STAFF REPORT

PLANNING & ZONING COMMISSION

1. SKETCH PLAN REVIEW

Applicant: Pulte Homes of Ohio LLC
Location: Steitz Road and Hunters Bend
Existing Zoning: Liberty Township Farm Residence District (FR-1)
Proposed Zoning: Planned Residence District (PR)
Request: To approve a Preliminary Development Plan proposed single-family residential subdivision consisting of 183 units on approximately 109 acres.

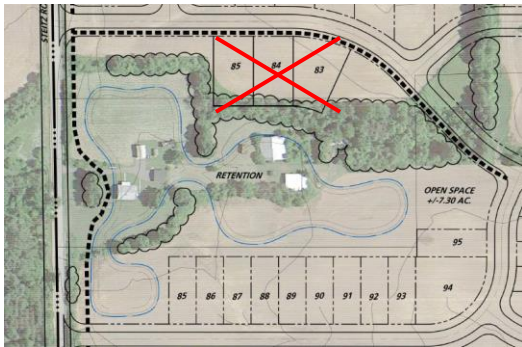
The applicant is proposing a 128 unit subdivision on roughly 70 acres. There are two housing types planned for in the subdivision, in the south west, smaller lots catering to empty-nesters, and retirees. The other type of housing in the remainder of the subdivision will be typical, large-lot single family homes. The home values will range from approximately \$400,000 to \$600,000+.

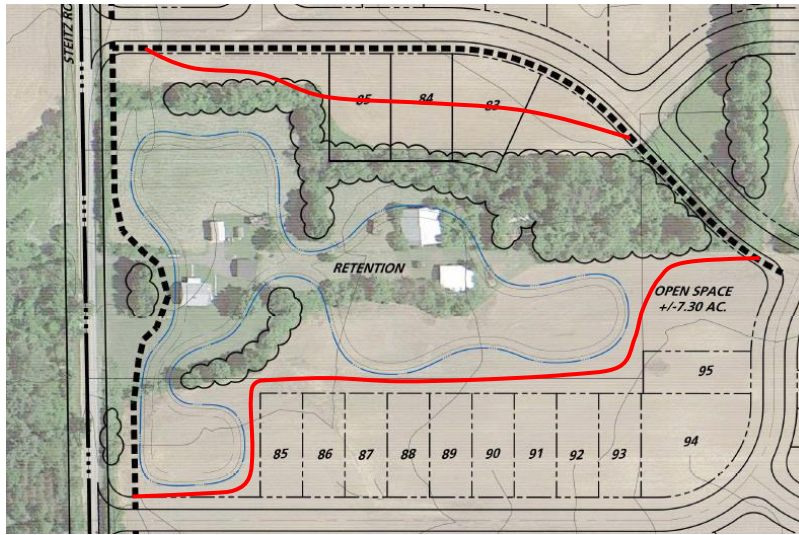
1. Remove lots 83, 84, and 85 from the northern main entrance road. This would increase the amount of open space and takes out lots that seem out of place. Furthermore, it would reduce the density of the project from 1.81 du/ac (dwelling units per acre) to 1.77 du/ac, which is more in line with the 1.7 du/ac maximum that staff feels is appropriate for this area of the city.

2. Have the multi-use paths go through the above open space area instead of at the edges. This would provide a loop trail that residents could use. Also, it improves safety, by taking the trail from the along the road to an interior space. Essentially, separating the pedestrian from the vehicle.
